Prairie Island Nuclear Generating Plant

PRAIRIE ISLAND NUCLEAR GENERATING PLANT  
Docket Nos. 50-282 License Nos. DPR-42  
50-306 DPR-60

Submittal of a Revised Figure Associated with  
Request for Relief #17 of the 3rd 10-Year Inservice  
Testing Program to the Requirements of ASME Section XI

Request for Relief #17  
Figure 1 Revision 1

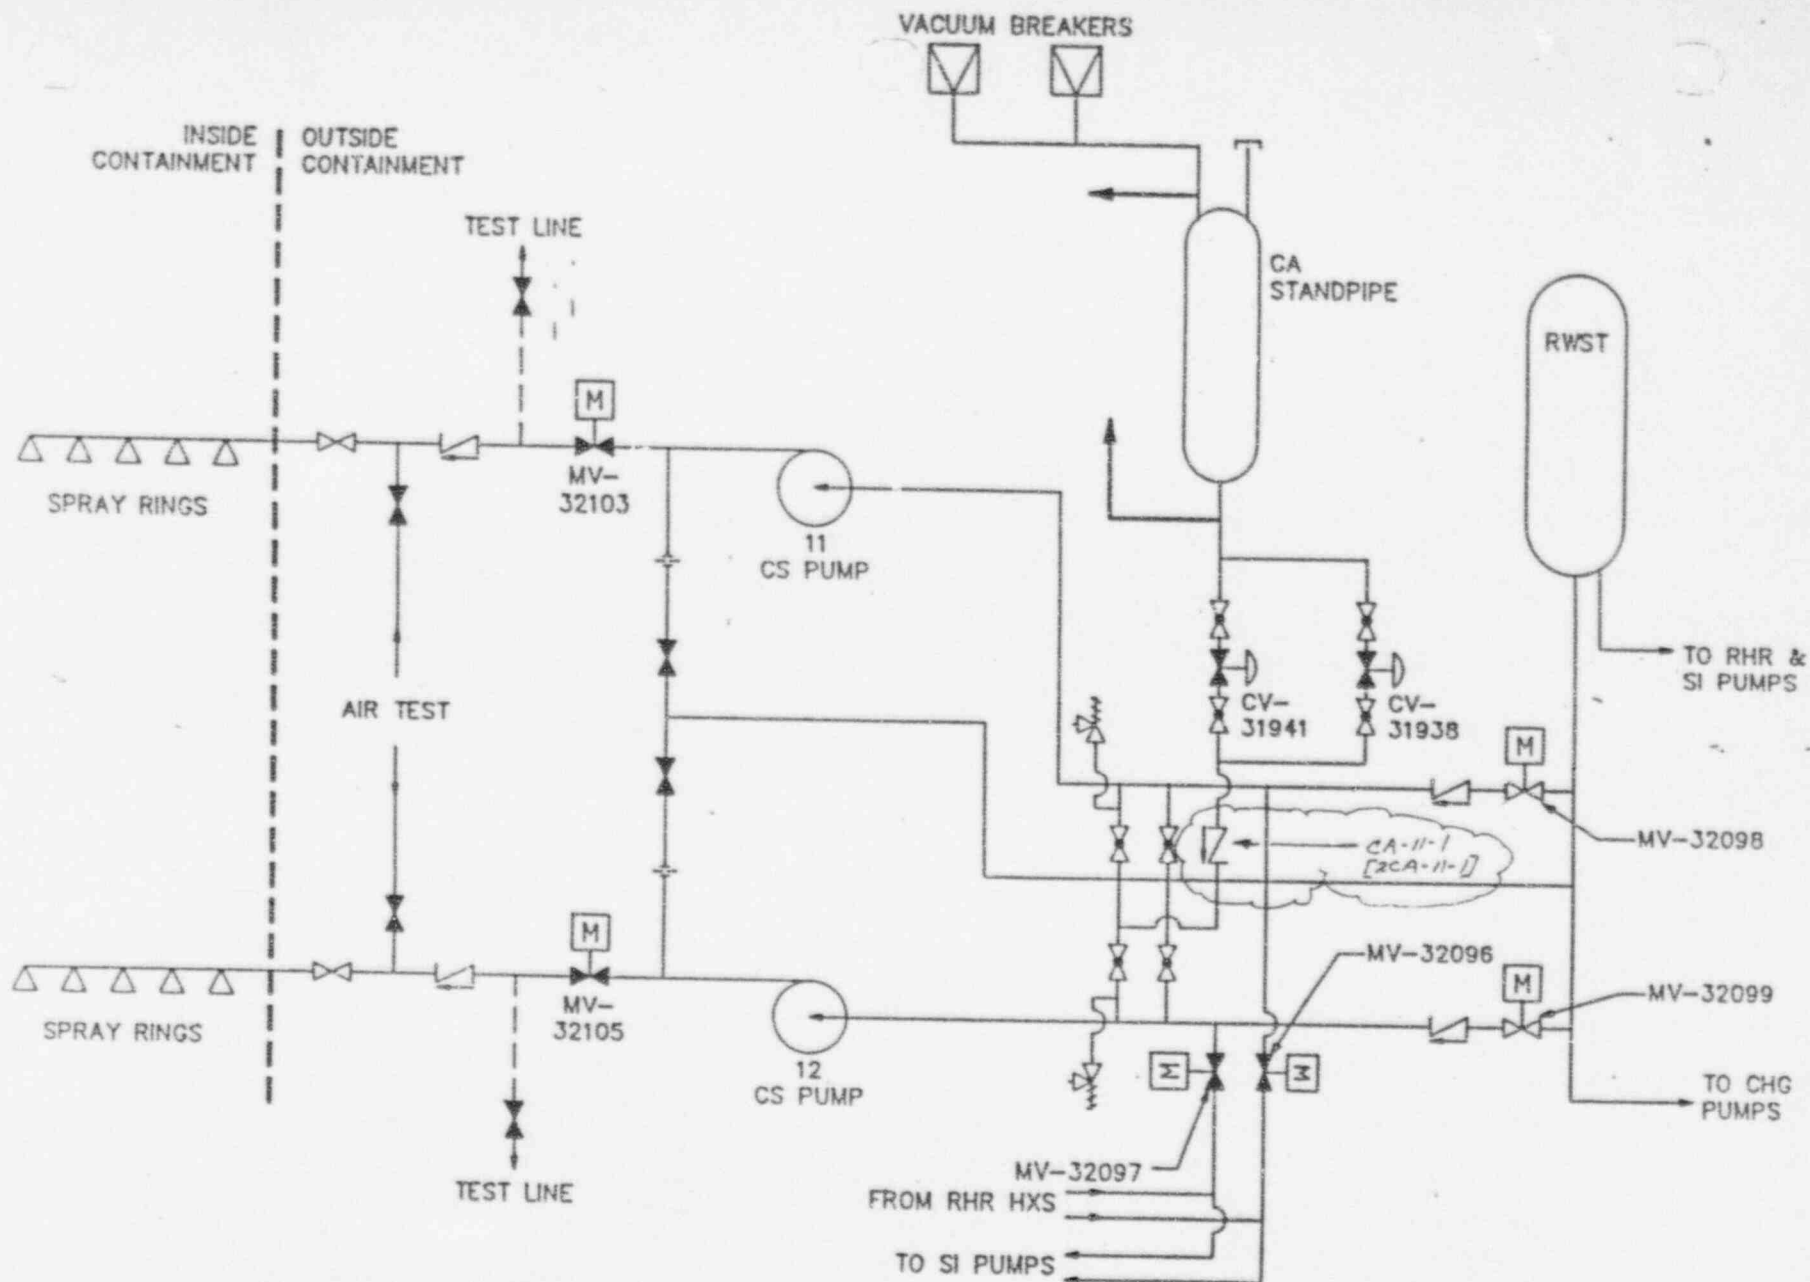
This submittal is being provided to correct an error of labeling of a valve on a figure submitted with a Request for Relief from ASME Section XI inservice testing requirements. On September 20, 1994, we submitted for NRC Staff review our 3rd 10-year Inservice Testing Program. In our submittal we requested relief from some requirements of the ASME Section XI Code. Request for Relief #17 had an attached figure of the Containment Spray System, entitled Request for Relief #17, Figure 1. This figure identified the valves to which the request applied. The figure highlighted the wrong valves and we are providing a corrected figure entitled, Request for Relief #17, Figure 1, Revision 1.
